Access Compliance Report

Public Rights-of-Way

Intersection ID: 16412	Main Street: COLVILLE_RD	Cross Street: TWIFORD_PL	Location: S
ADA ID: A6404C7C9CB5	Ramp Type: BlendTrans2	Initial Pass/Fail: Fail	Overall Compliance: No
		Severity Score: 1.25

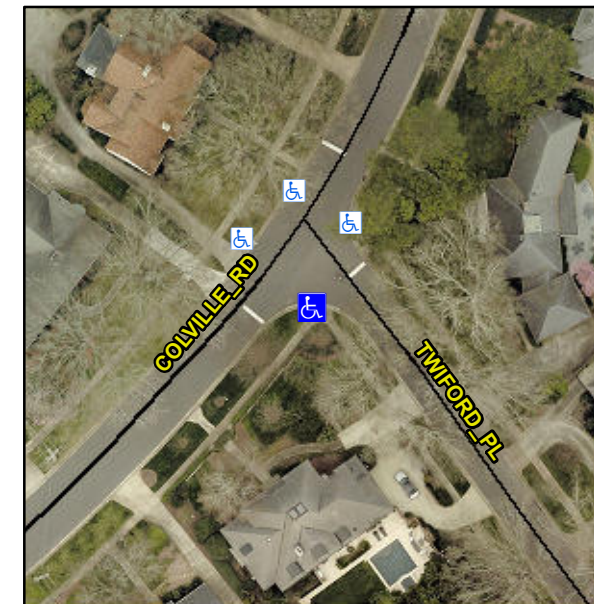
R304.5.3

Compliance	Description	Data	Compliance	Description	Data
N/A	Ramp Length (in)	94.5	Yes	BlendTrans Slope (%)	3.3
Yes	Ramp Width (in)	60.0	No	BlendTrans XSlope (%)	4.9
N/A	Flare Type LT	N/A	N/A	Flare Type RT	N/A
N/A	Flare Slope LT (%)	N/A	N/A	Flare Slope RT (%)	N/A
N/A	Flare Traversable LT?	N/A	N/A	Flare Traversable RT?	N/A
N/A	Landing Length (in)	N/A	N/A	DWS Provided?	N/A
N/A	Landing Width (in)	N/A	N/A	DWS Contrast?	N/A
N/A	Landing Slope (%)	N/A	N/A	DWS Length (in)	N/A
N/A	Landing X Slope (%)	N/A	N/A	DWS Full Width?	N/A
N/A	Landing Curb? (Y/N)	N/A	N/A	DWS Offset (in)	N/A
N/A	Shared Landing?	N/A			
N/A	Gutter Ponding?	N/A	N/A	Gutter Slope (%)	N/A
N/A	Gutter Lip Ht (in)	N/A	N/A	Gutter X Slope (%)	N/A
N/A	Painted X Walk1?	No	N/A	Painted X Walk2?	No
	X Walk 1 Direction	To NE		X Walk 2 Direction	To NW
	X Walk 1 Width (in)	N/A		X Walk 2 Width (in)	N/A
	X Walk 1 Slope (%)	6.8		X Walk 2 Slope (%)	2.1
	X Walk 1 X Slope (%)	1.3		X Walk 2 X Slope (%)	8.5

Remove & Replace Curb Ramp With Two New Directional Ramps or Equivalent.
